Melbourne Planning Scheme Amendment C384

Land subject to inundation from riverine and drainage flooding

Statement of Expert Urban Design Evidence,
prepared by Alastair Campbell, Hansen Partnership
for City of Melbourne

Extract of Figures 31 & 32 showing NFPL on cross-sections

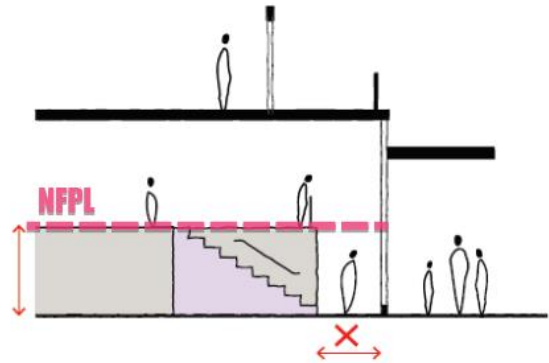
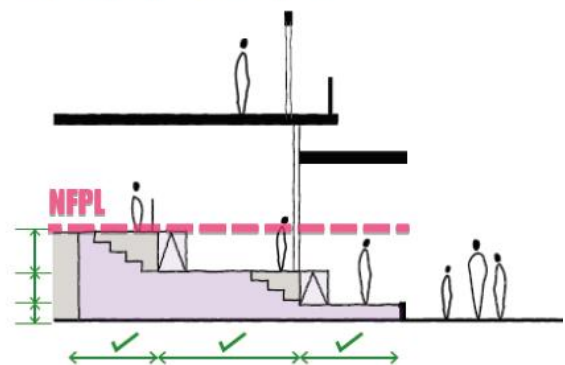
- Adding NFPL designation (as a red dashed line) to cross-section Figures 31, 32, 33, 37 and 46;
 - Remove specific reference to photographer for Figures 22 and 27, in Appendix – Photo Credits.

Add NFPL designation to cross-sections

95. Figure 7, introduces the graphic representation of NFPL in the document, by-way of a red dashed line on the cross-section. This graphic convention is then utilised on Figures 25 and 26, in relation to substation positioning and car park access ramps. Therefore, for clarity I consider that this red dashed line should also be added to further cross-sections within the Guide. I consider the relevant five cross-sections that the NFPL level should be depicted to be Figures 31-33, 37 and 46.

- Revise its title to remove reference to 'Fishermans Bend, Arden and Macaulay';
- Adjustment to the footnote numbering throughout the document;
- Add NFPL designation to cross-section Figures 31, 32, 33, 37 and 46; and
- Remove specific reference to photographer for Figures 22 and 27, in Appendix – Photo Credits.
